ARKANSAS POWER AND LIGHT COMPANY

ARKANSAS NUCLEAR ONE, UNIT 2

AMENDMENT TO FACILITY OPERATING LICENSE

Amendment No. 29
License No. NPF-6

FIGURE 6.2-2' Functional Organization for Plant Operation

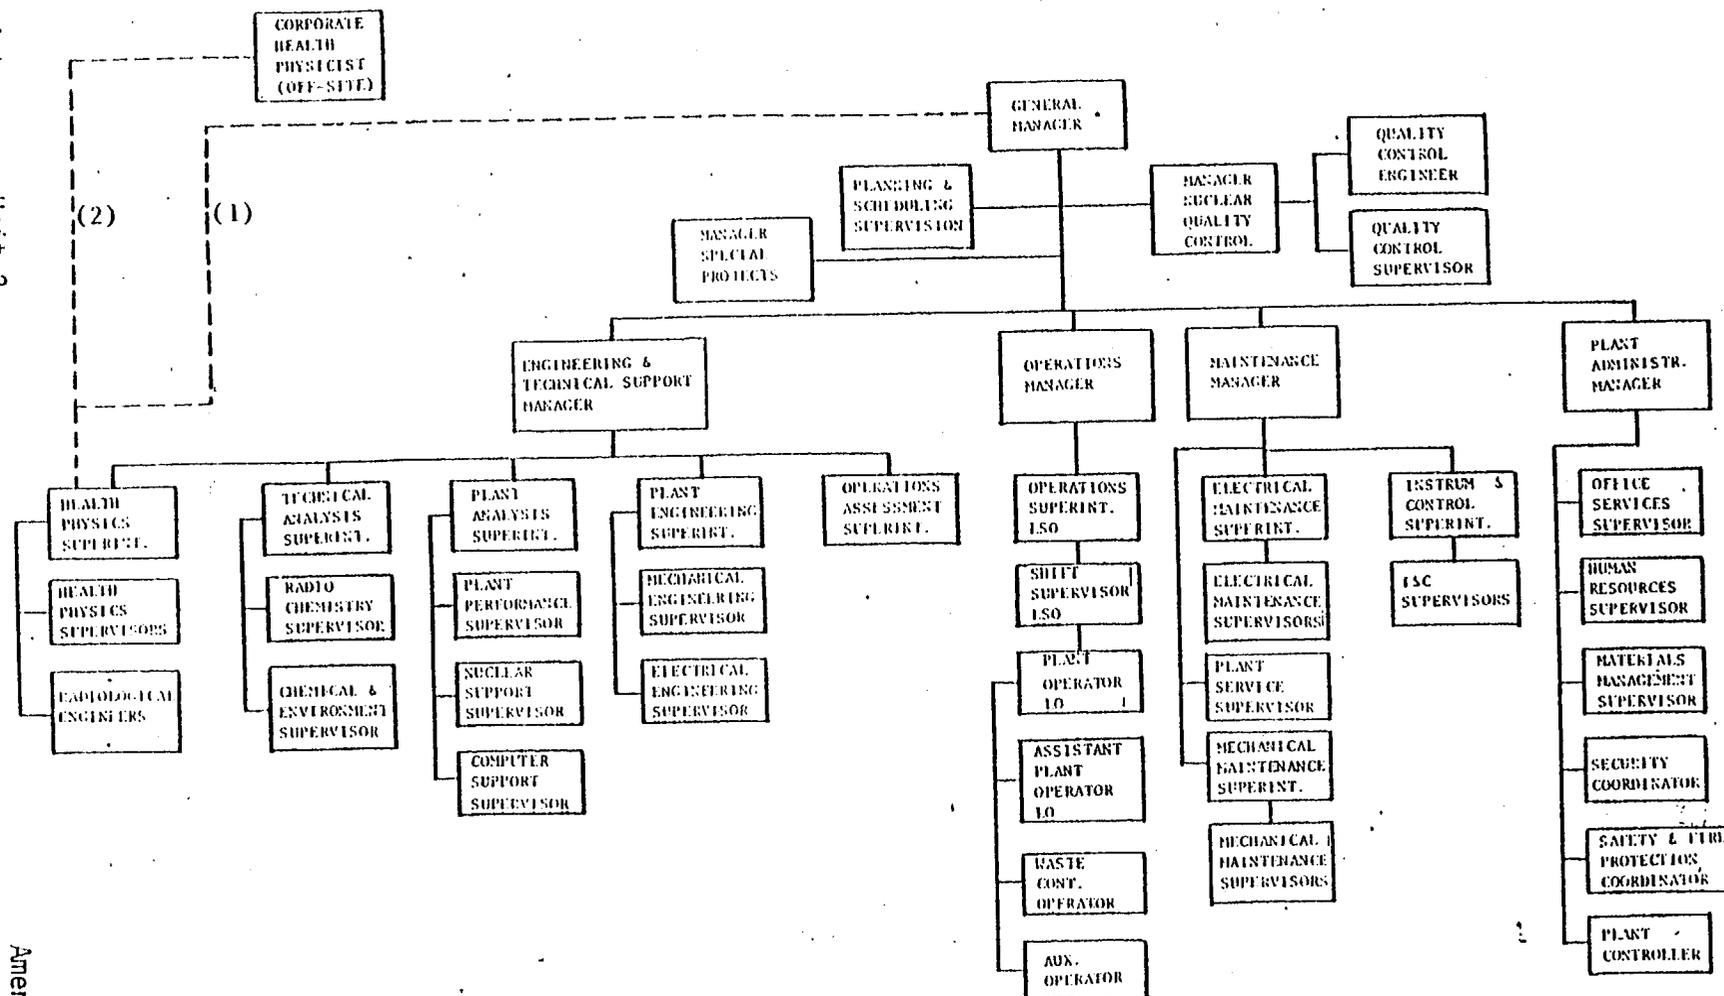
By application dated October 8, 1981 the licensee proposed to amend the portion of the TS addressing the organization of the plant staff health physics section. The changes consist of creation of the position of Health Physics Superintendant and the addition of a communication interface with the Corporate Health Physicist who is located offsite.
